**Rezoning Transportation Analysis**  
**Petition Number: Insert Zoning Petition #2021-270**  
*General Location Identifier: 10502126, 10502127*

**Revision Log:**

Date	Description
04-12-2022	First Review (AO)
05-25-2022	Second Review (AO)
06-29-2022	Third Review (AO)

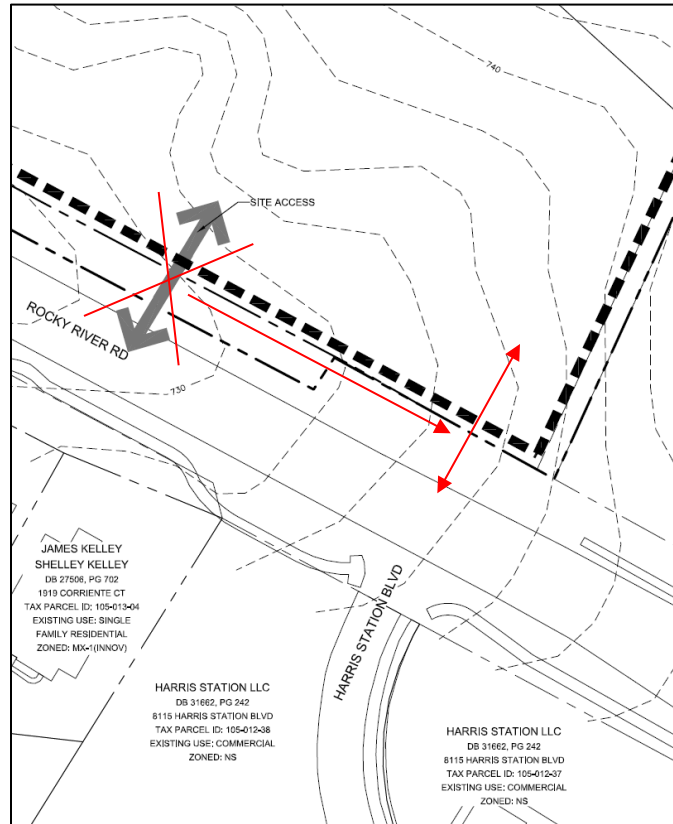
1. **Outstanding Comment from 04-12-2022:**

**Curbline:**

- a. **Rocky River Road:** Distance from centerline to back of curb: 19 feet

Label and dimension the curb and gutter from the centerline for each road on the site plan.

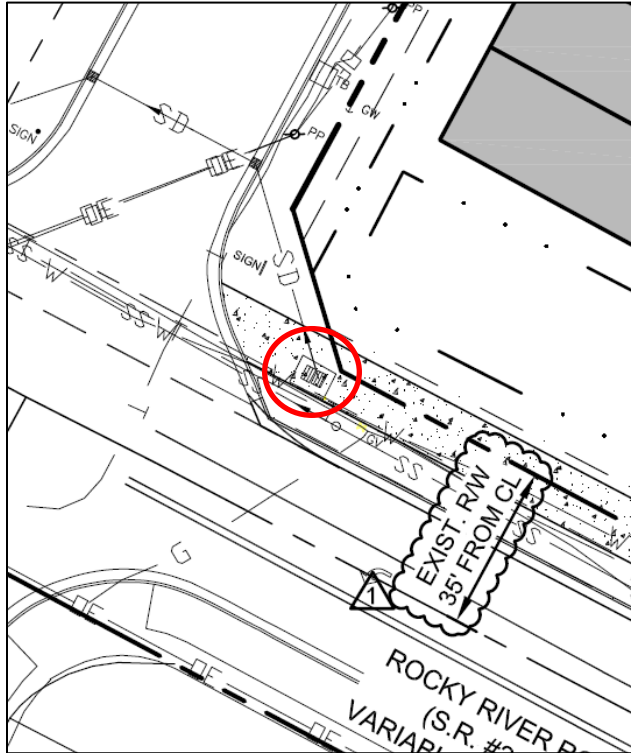
- 11. **Update to Comment (New Site Plan, 6-28-2022):** ~~Revise site plan and conditional note(s) to commit to relocating existing storm drainage infrastructure to location to be determined during permitting. Revise site plan removing existing storm drainage from site plan that is currently showing it in the proposed multi-use path.~~

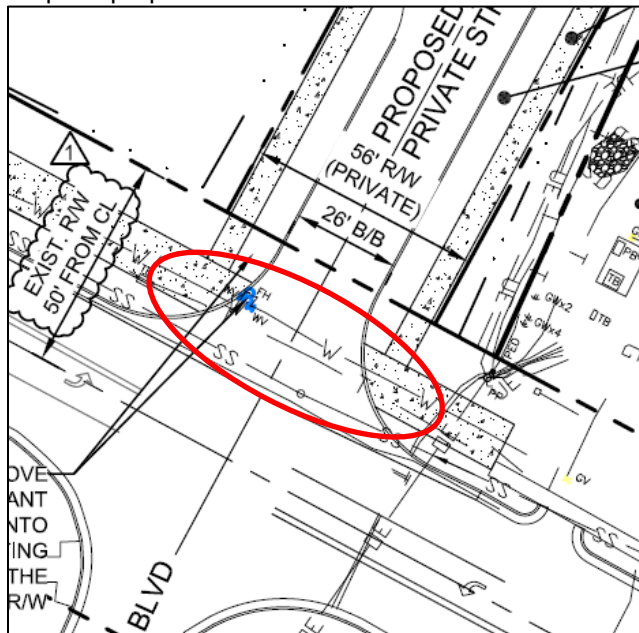
- 12. **Resolved (New Site Plan, 6-28-2022)** ~~Revise site plan and conditional note(s) to commit to constructing ADA curb ramps at proposed street intersections.~~
